# Wollongong Local Planning Panel Assessment Report | 3 July 2019

<b>WLPP No.</b>	Item 2
<b>DA No.</b>	DA-2018/473
<b>Proposal</b>	Commercial - Demolition of existing buildings and construction of mixed use building containing 2 levels of basement car parking (94 cars), three ground floor commercial / retail spaces, and 84 residential units above with a roof terrace
<b>Property</b>	49-51 Denison Street, Wollongong; Lot 1 DP 1108504
<b>Applicant</b>	Wollongong Investments No 2 Pty Ltd
<b>Responsible Team</b>	Development Assessment and Certification - City Centre Team (TW)

## ADDENDUM REPORT AND RECOMMENDATION

Figure 1 - Extract of Level 2 Floor Plan.

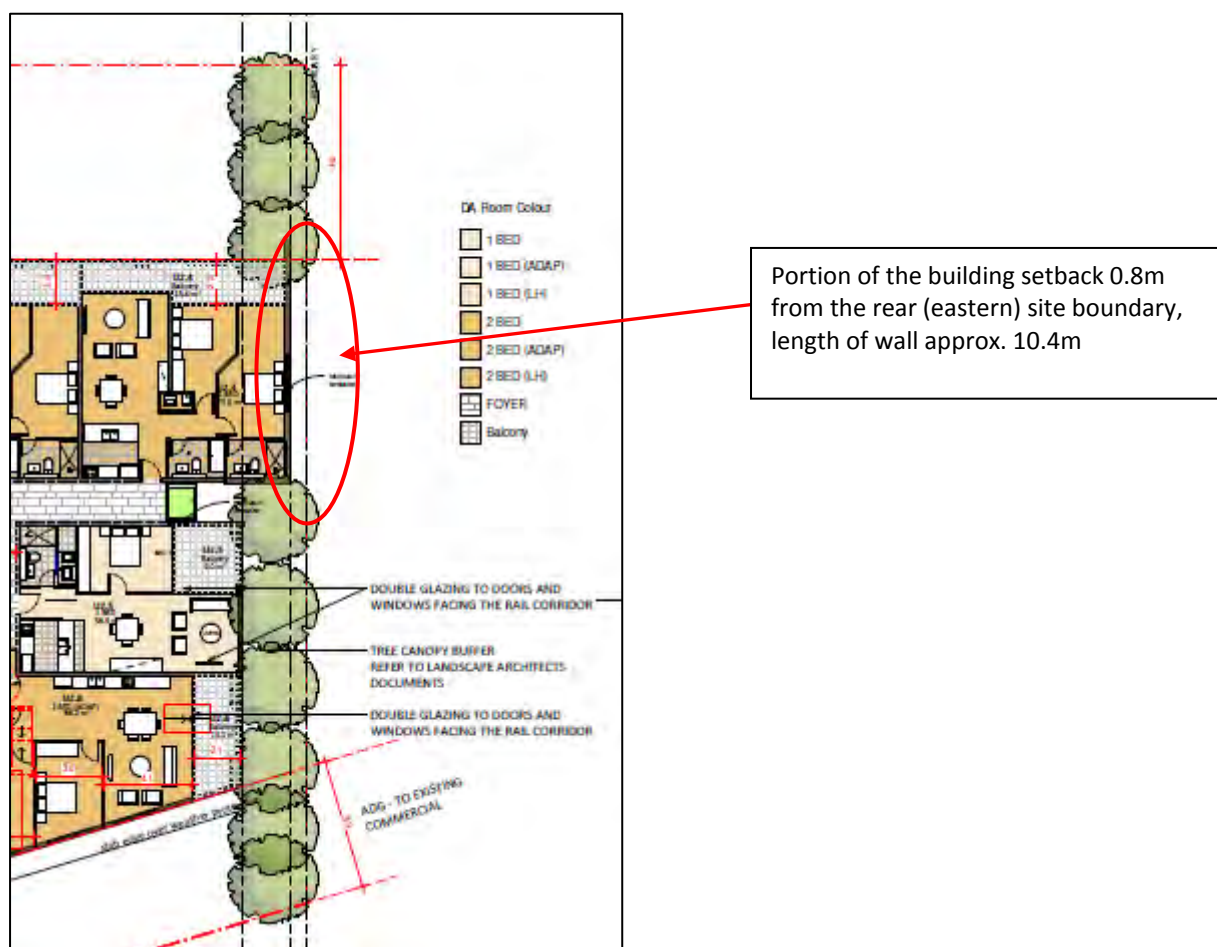
The plans have however been revised to provide for a 3m setback to most of the length of the site for Levels 1 – 8. A section of the building does however remain proposed on a 0.8m setback from the rear boundary, as illustrated in an extract of the typical floor plan below:-

Figure 2 - Extract of Section

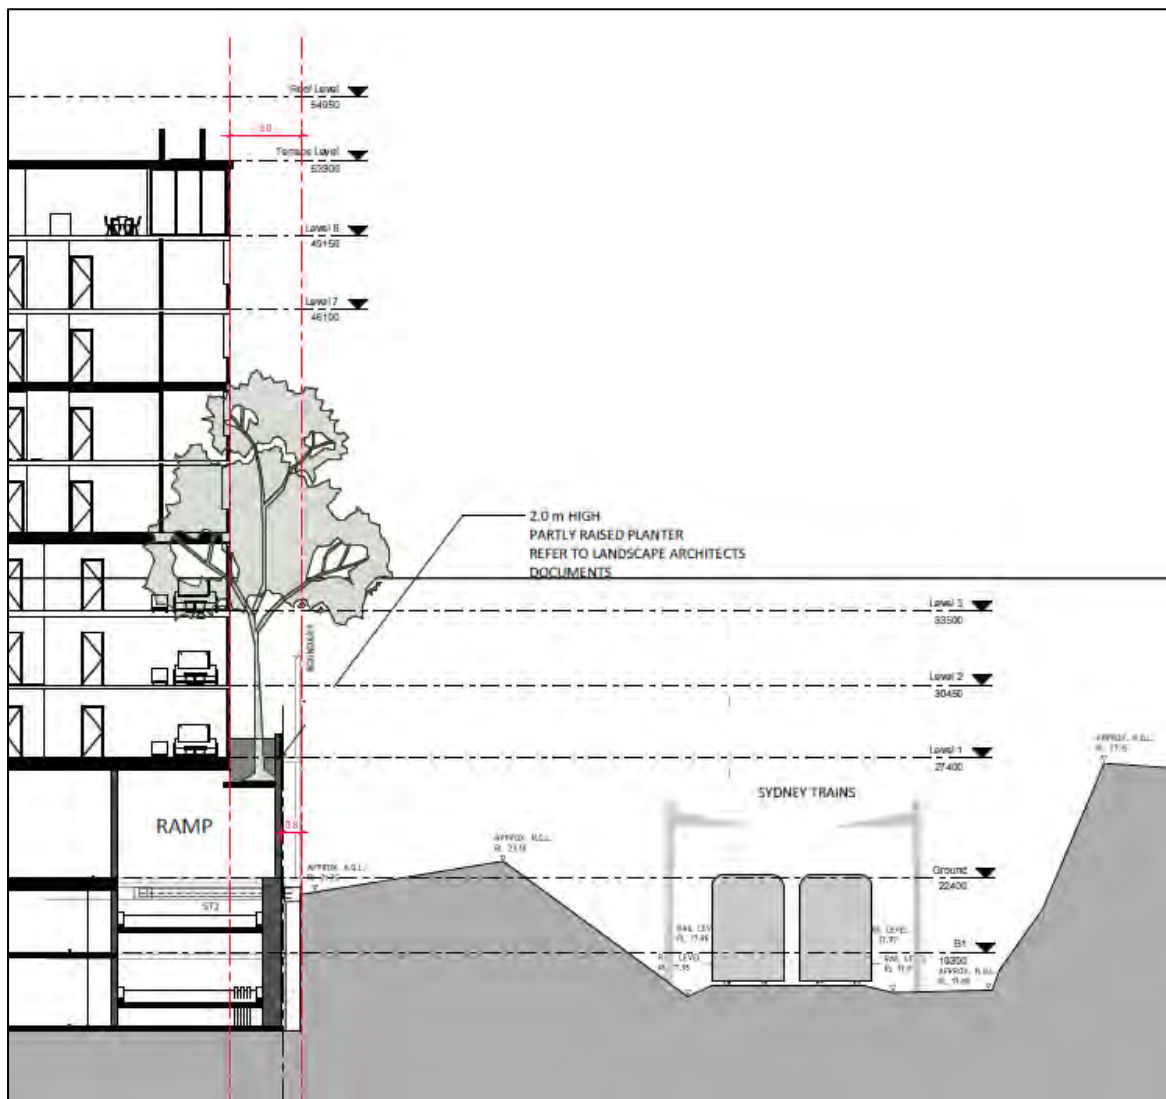
Figure 2 illustrates the relationship between the proposed building and the adjacent rail corridor. The section is taken through that part of the building setback 3m from the eastern (rear) property boundary and indicates where planting on structure is proposed to be provided as required by the Panel. The landscape planter will have a planting medium depth of 2m which will be sufficient for reasonable height screening plants to be planted. A revised landscape plan consistent with the amended architectural plans has been submitted which provides for the planting of Blueberry Ash trees and other under-canopy planting within the rear planter box. The Blueberry Ash is expected to reach a height of 8m at maturity which should be sufficient in offering some screening of the rail corridor up to Levels 6 and 7 for reasons of visual amenity and to improve the internal visual privacy of the rear-facing units from the east.

Notwithstanding the above a 3 metre (m) building setback has been provided to part of the east boundary to provide for a sunken planter deep enough to facilitate 6-8m high trees to screen the rail line. This change is shown in the section drawing No. DA002F.
